STATE OF OHIO
DEPARTMENT OF TRANSPORTATION
MAH-680-4.58
PART 1
CITY OF YOUNGSTOWN
MAHONING COUNTY
FOR PART 2 SEE MAH-680-4.58

FEDERAL PROJECT NUMBER
E250327
RAILROAD INVOLVEMENT
NONE
PROJECT DESCRIPTION
THE PROJECT CONSISTS OF FULL DEPTH PAVEMENT REPLACEMENT OF MAHONING I.R. 680 FROM THE S.R. 193 INTERCHANGE (SLM-4.58) TO SOUTH OF THE SOUTH AVENUE INTERCHANGE (SLM-7.37), ALL INTERCHANGE RAMPS WITHIN THE CORRIDOR WILL BE RECONSTRUCTED, INCLUDING RAMPS TO AND FROM S.R. 193 AND U.S. 62/S.R. 7. INCLUDES BRIDGE WORK TO MAH-680-4.886 (SFN 5006872). THIS PROJECT ALSO INCLUDES THE REMOVAL OF THE MAHONING AVENUE ENTRANCE RAMP TO I.R. 680 SOUTHBOUND.
ADDITIONAL WORK INCLUDES GUARDRAIL AND CONCRETE BARRIER REPLACEMENT, ROADWAY DRAINAGE IMPROVEMENTS, SIDEWALK, CURB RAMPS, SIGNING, LIGHTING AND PAVEMENT MARKINGS.

R3 01-13-2026, SUPPLEMENTAL SPECIFICATIONS 813 AND 913 ADDED

CROSS SECTIONS - I.R. 680
 STA. 992+00.00 TO STA. 996+00.00

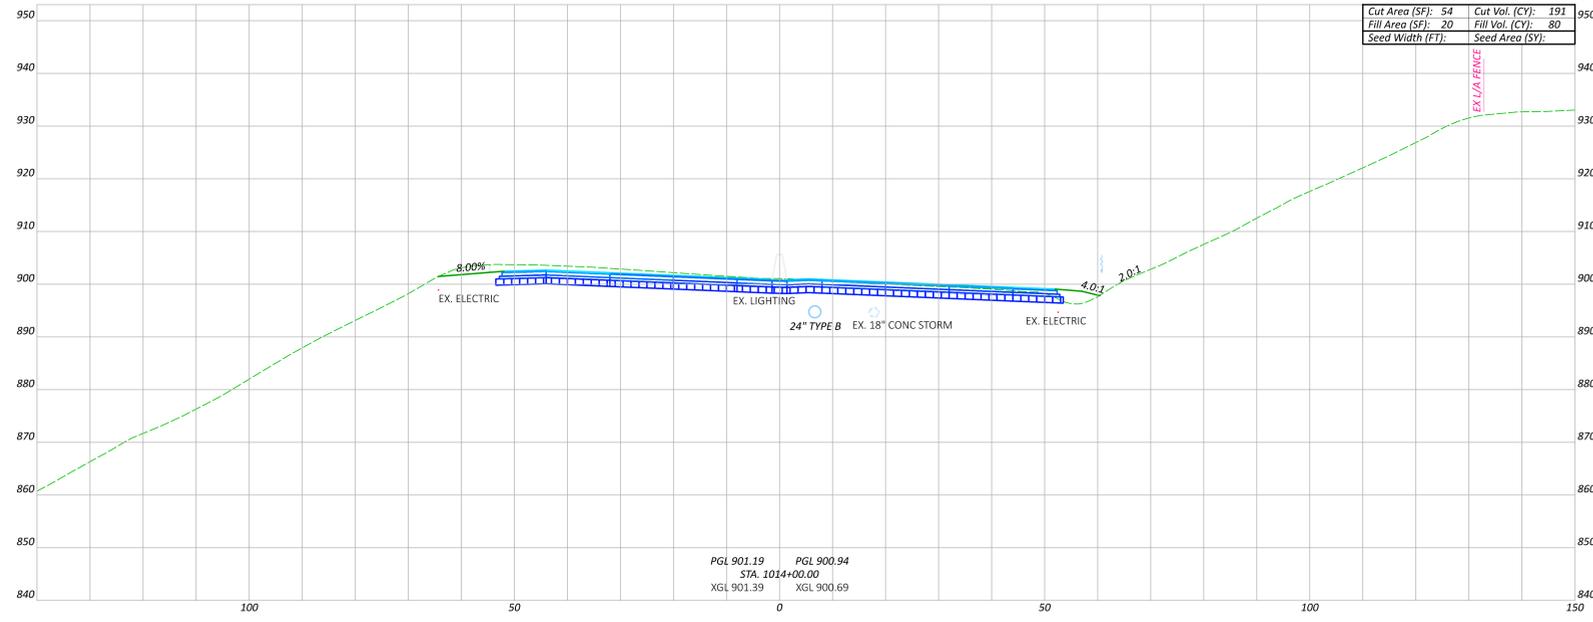
R3 01-13-2026, QUANTITIES REVISED
 Sheet Totals: 121474
 Seeding: 506 / 477

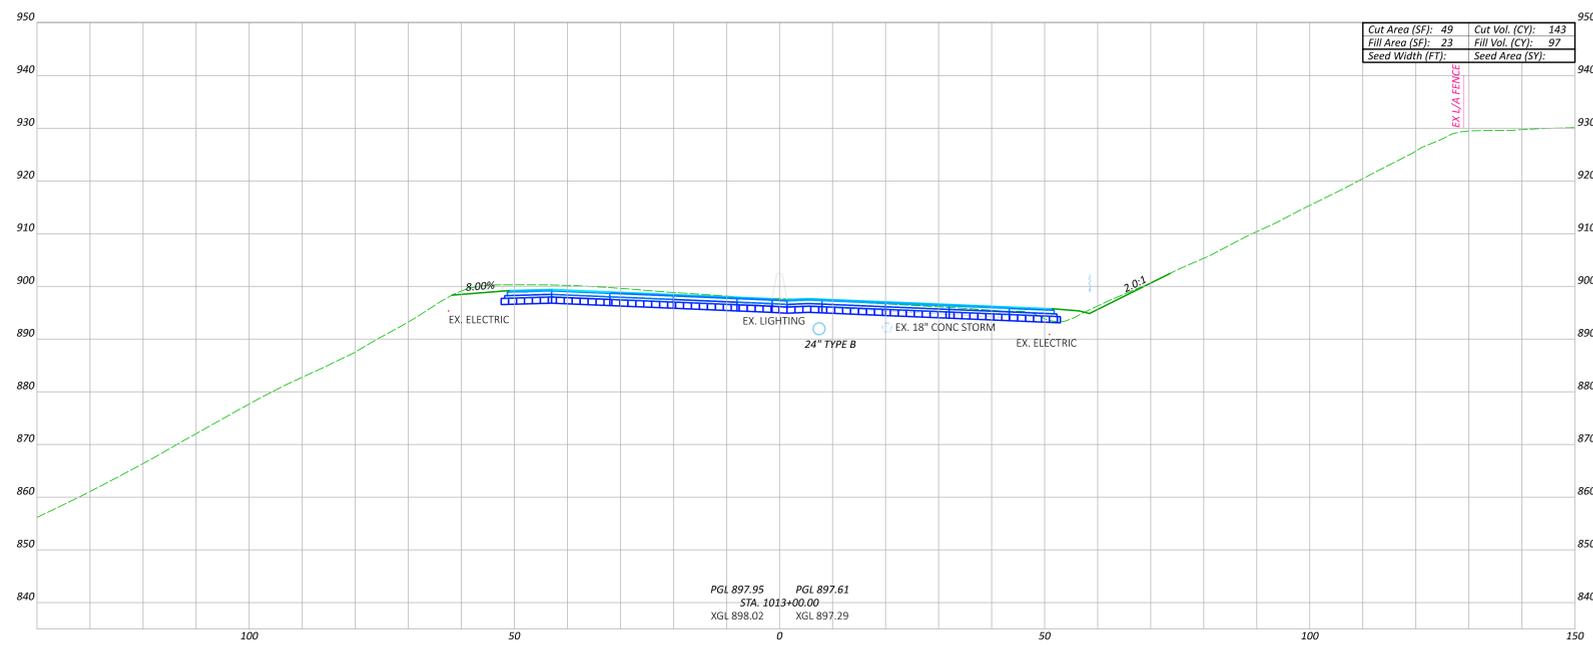
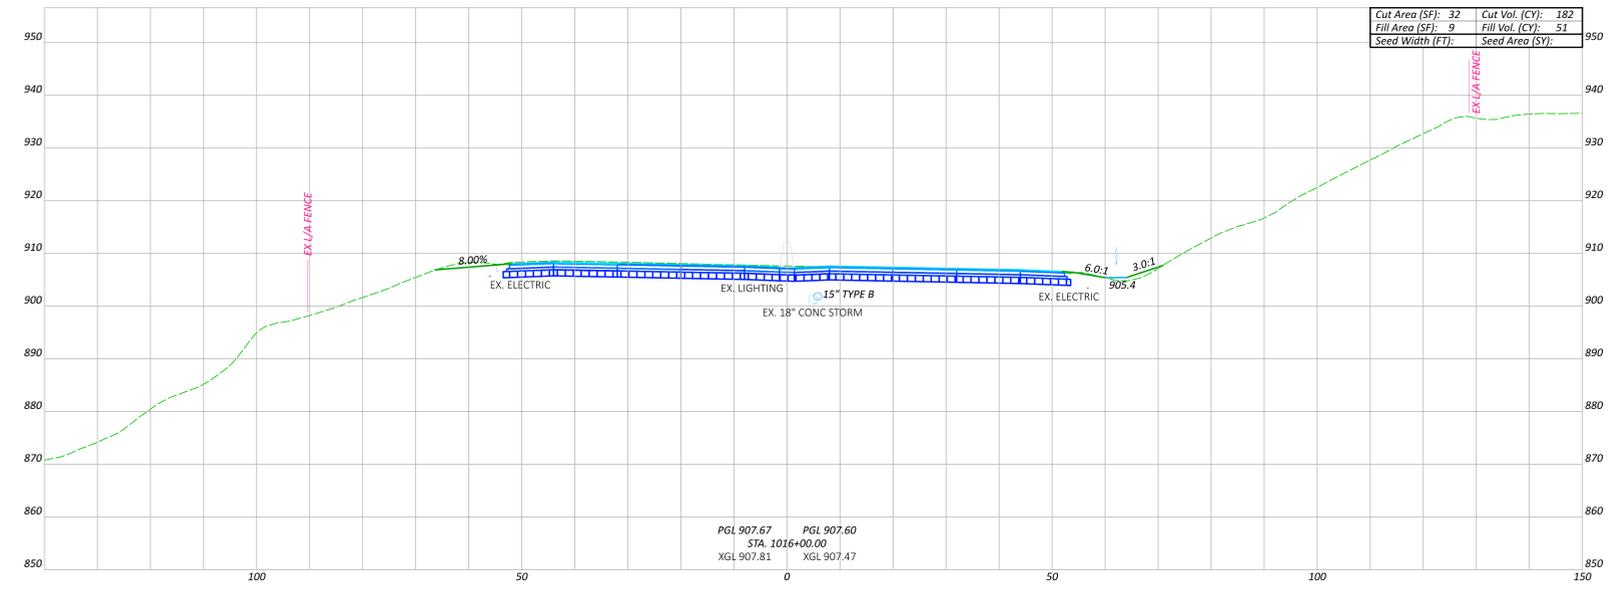
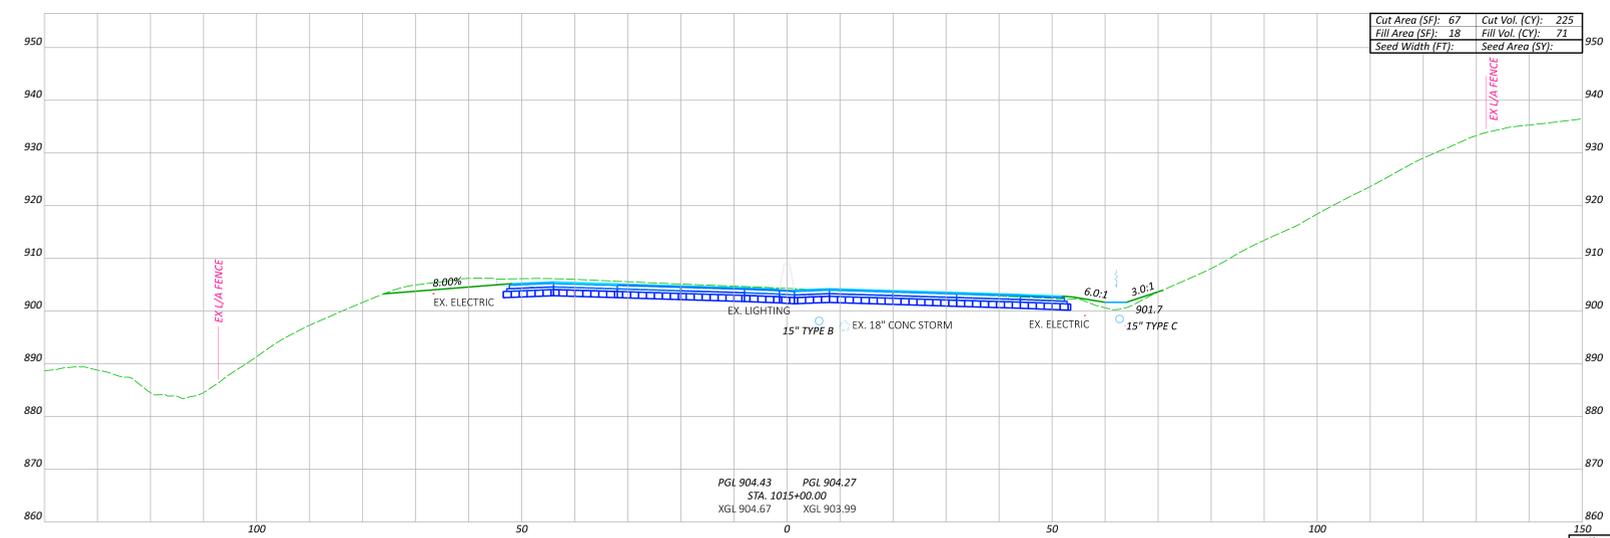
R3 01-13-2026, QUANTITIES REVISED

CROSS SECTIONS - I.R. 680
 STA. 1021+75.00 TO STA. 1025+00.00

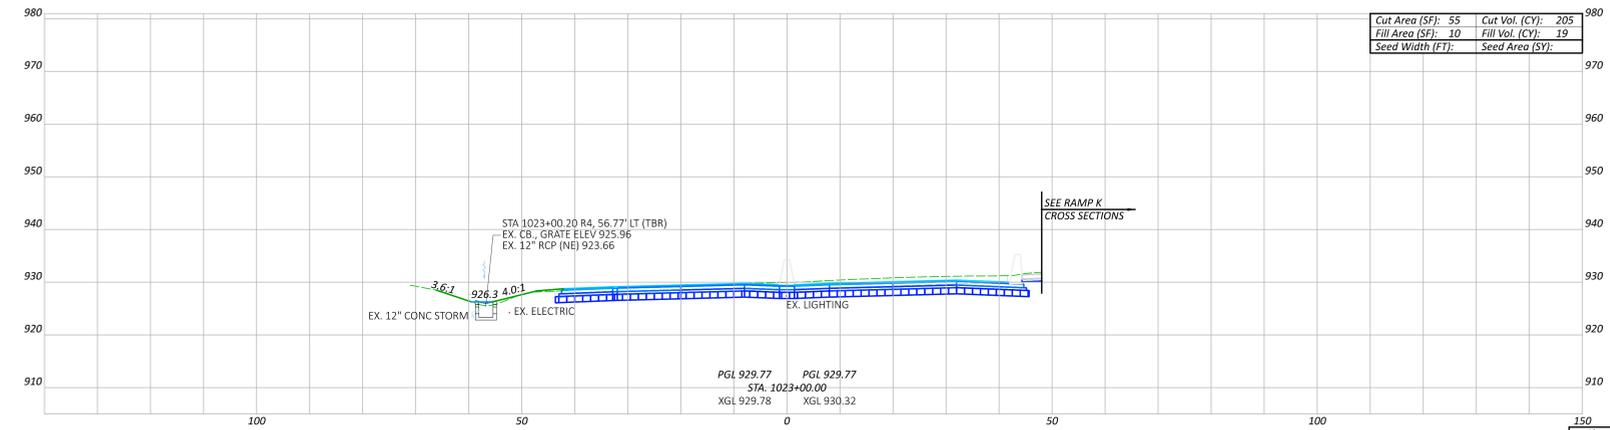
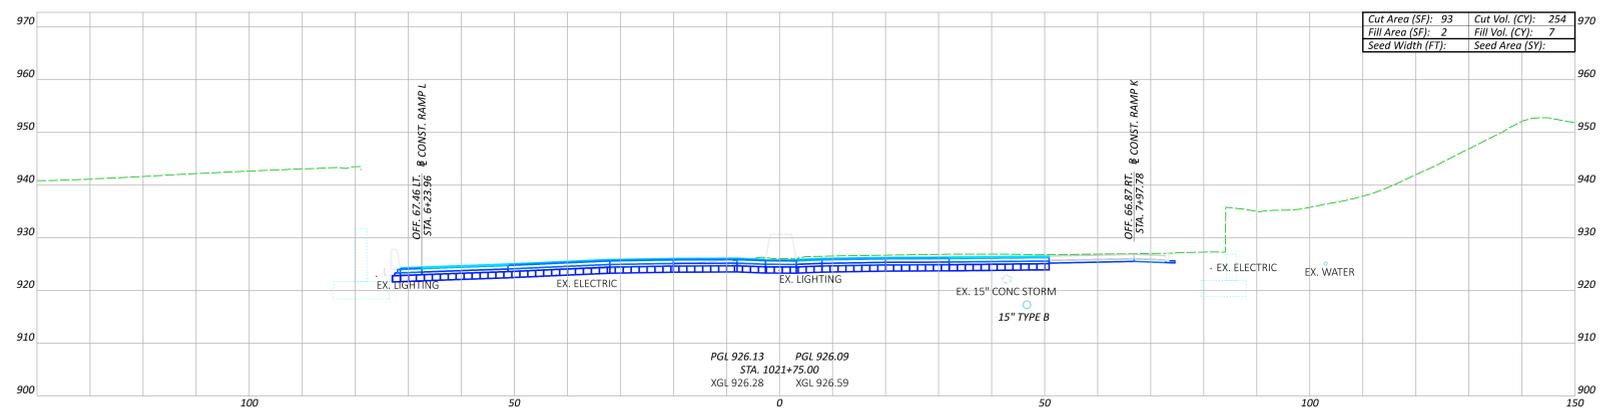
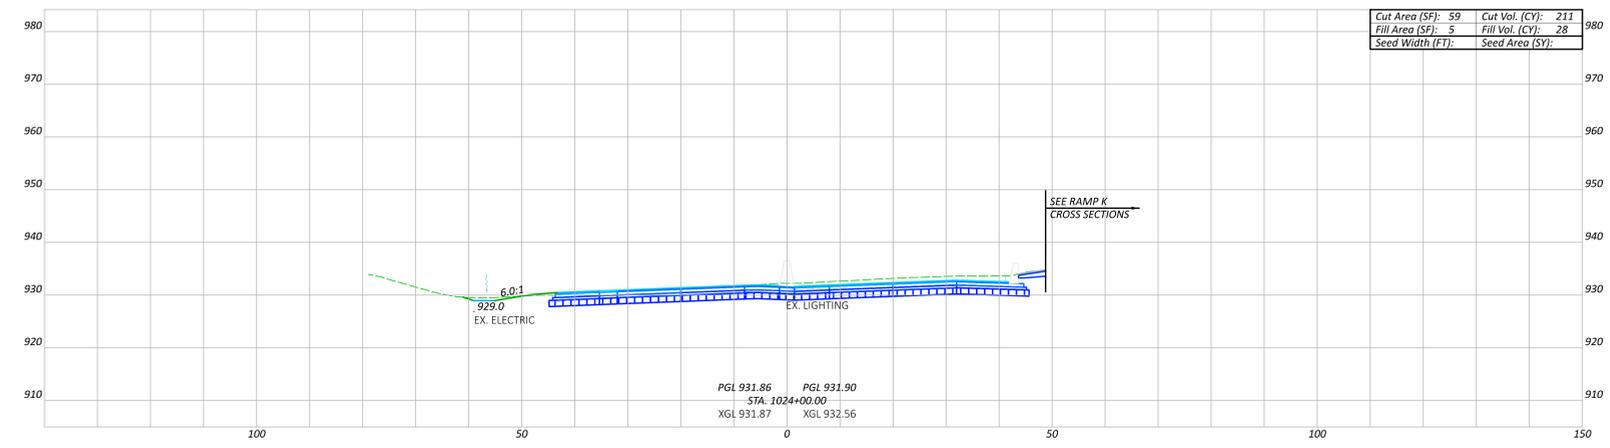
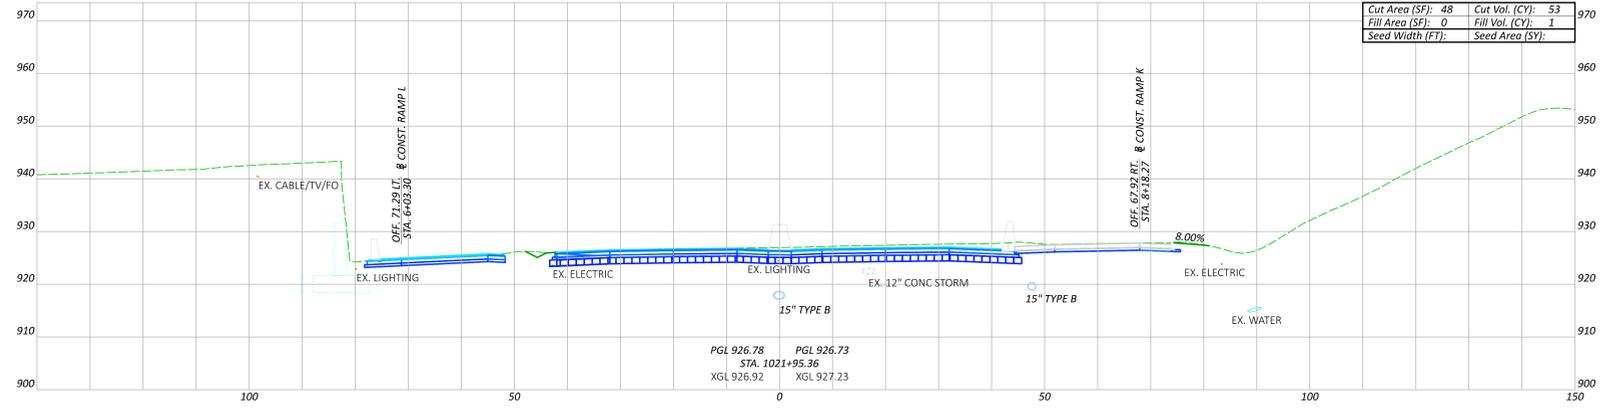
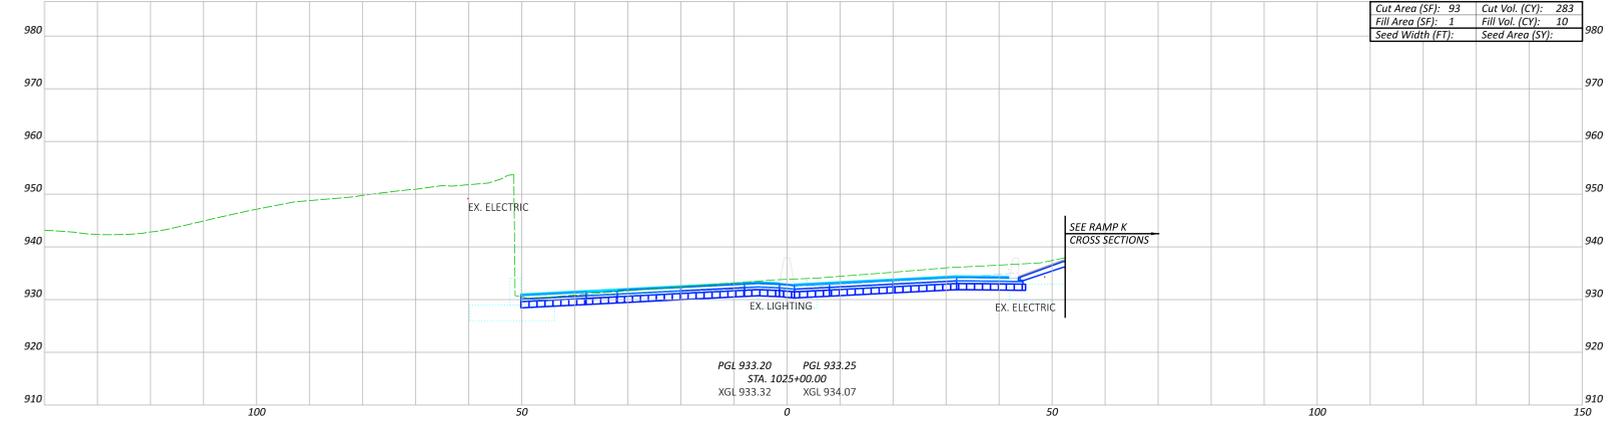
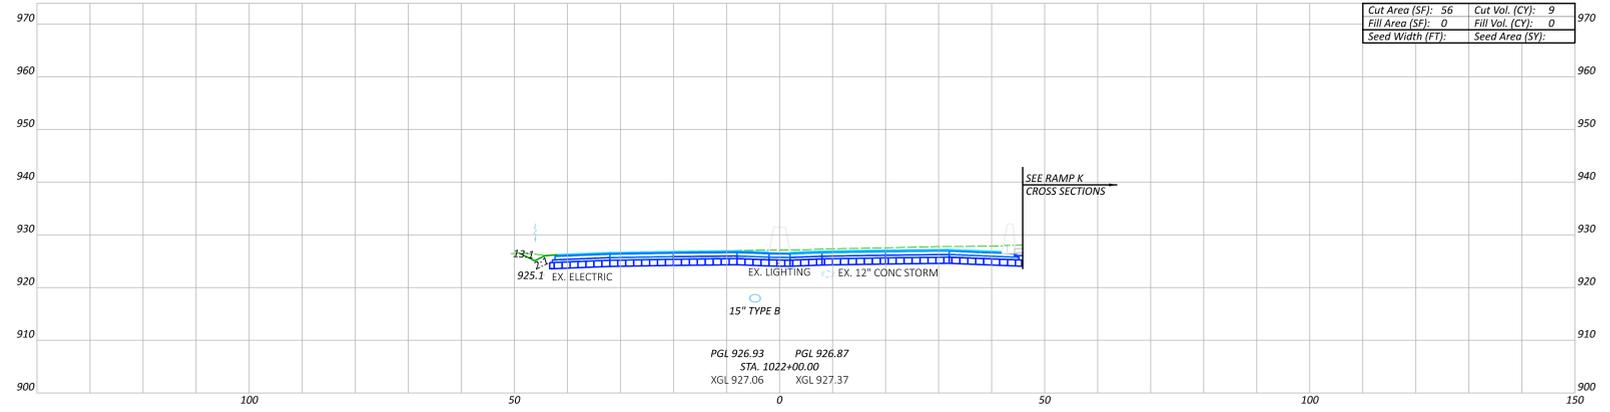
01-13-2026, QUANTITIES REVISED
